More efficient LDPC Parity Code Matrix and downstream FEC draft text (rev 1b)

23 January 2018 IEEE 802.3 Interim, Geneva Switzerland

AWGN Performance

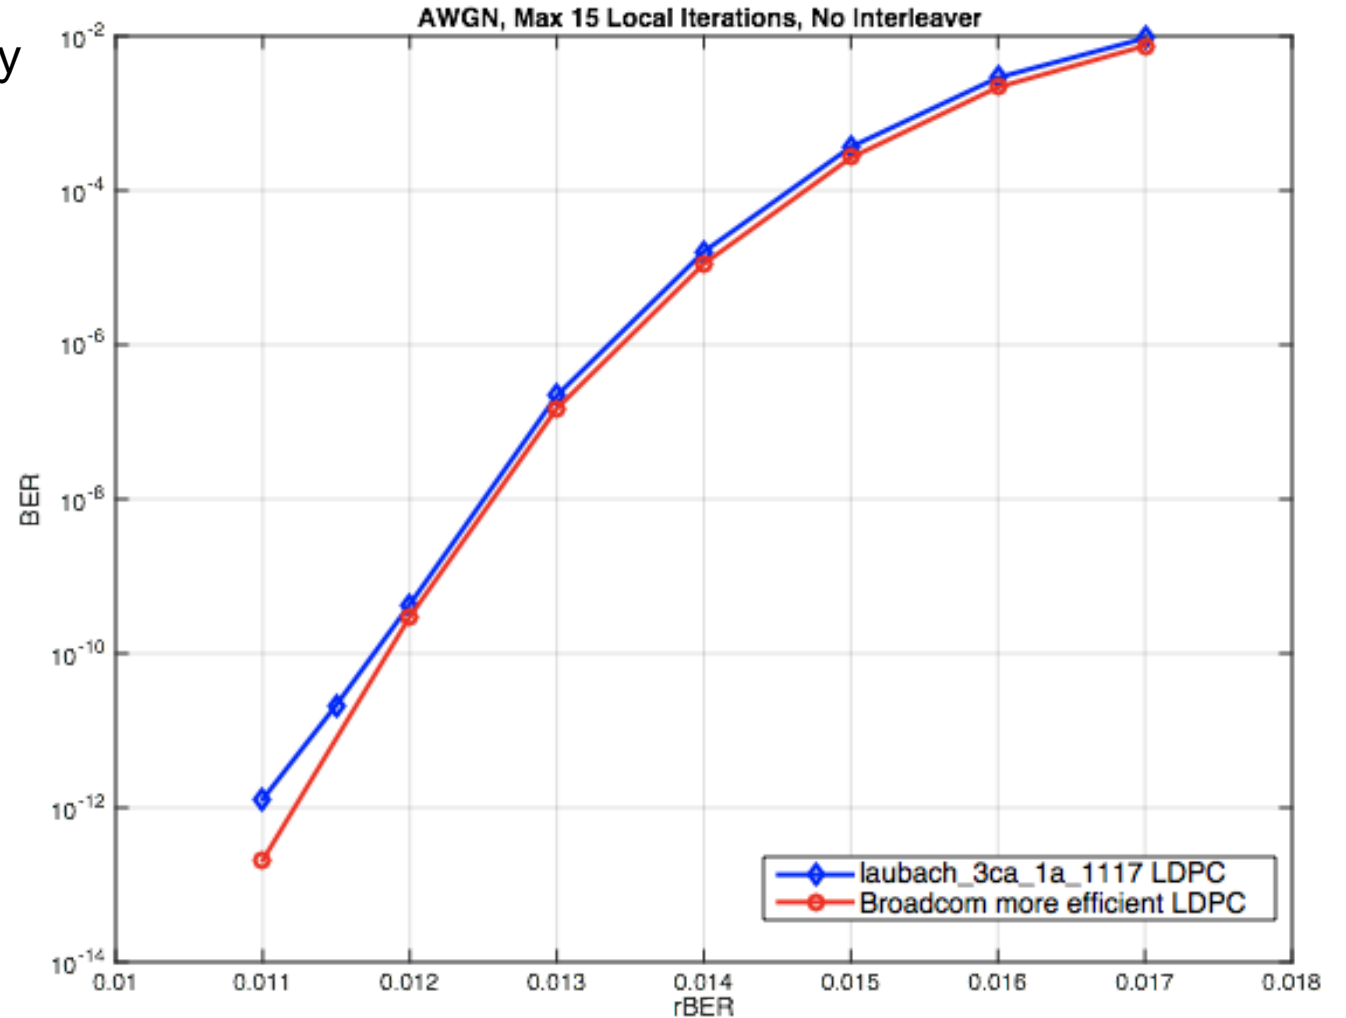
- Improved error floor performance without any fixed-point features.
- Gain improvement: 2.60 dB to 2.63 dB.
- Note: From previous presentation, using an interleaver has no impact on AWGN performance.

Gilbert Burst Model Performance

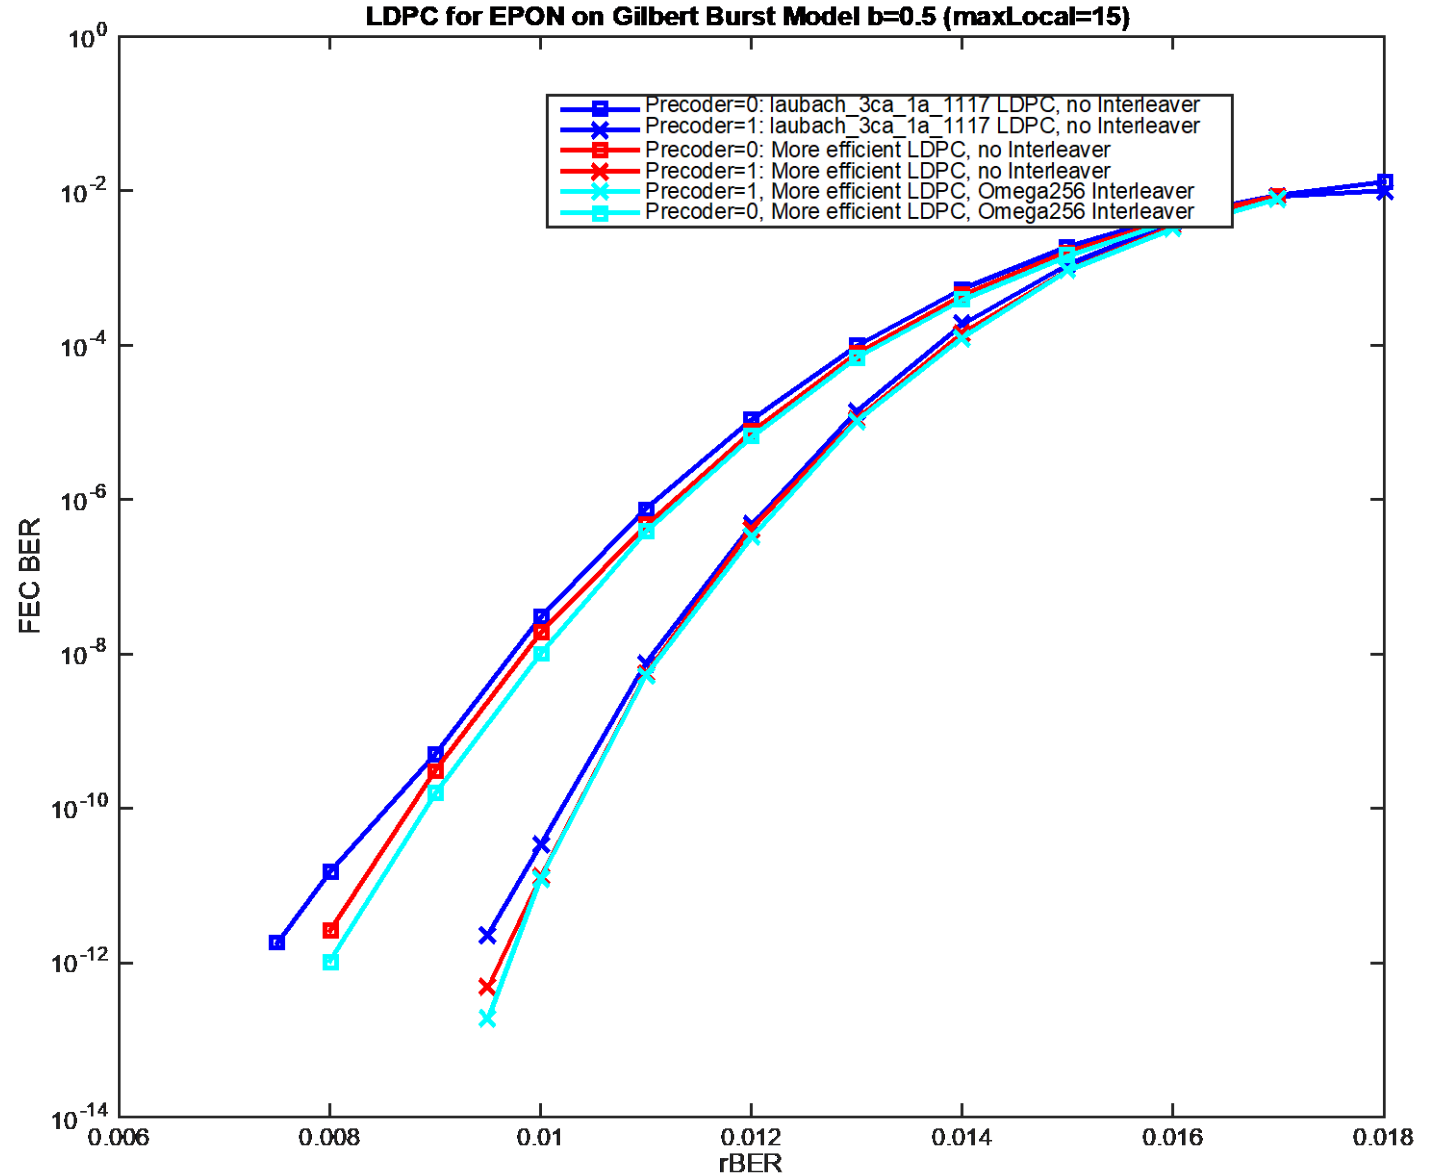
- Precoder on/off, no interleaver
- Gain improvement:
 - Precoder on:
 - 2.03 dB with interleaver (previous) to:
 - 2.11 dB without interleaver
 - **2.12** with interleaver (rev 1b)
 - Precoder off:
 - 1.78 dB with interleaver (previous) to:
 - 1.85 dB without interleaver
 - **1.87** dB with interleaver (rev 1b)
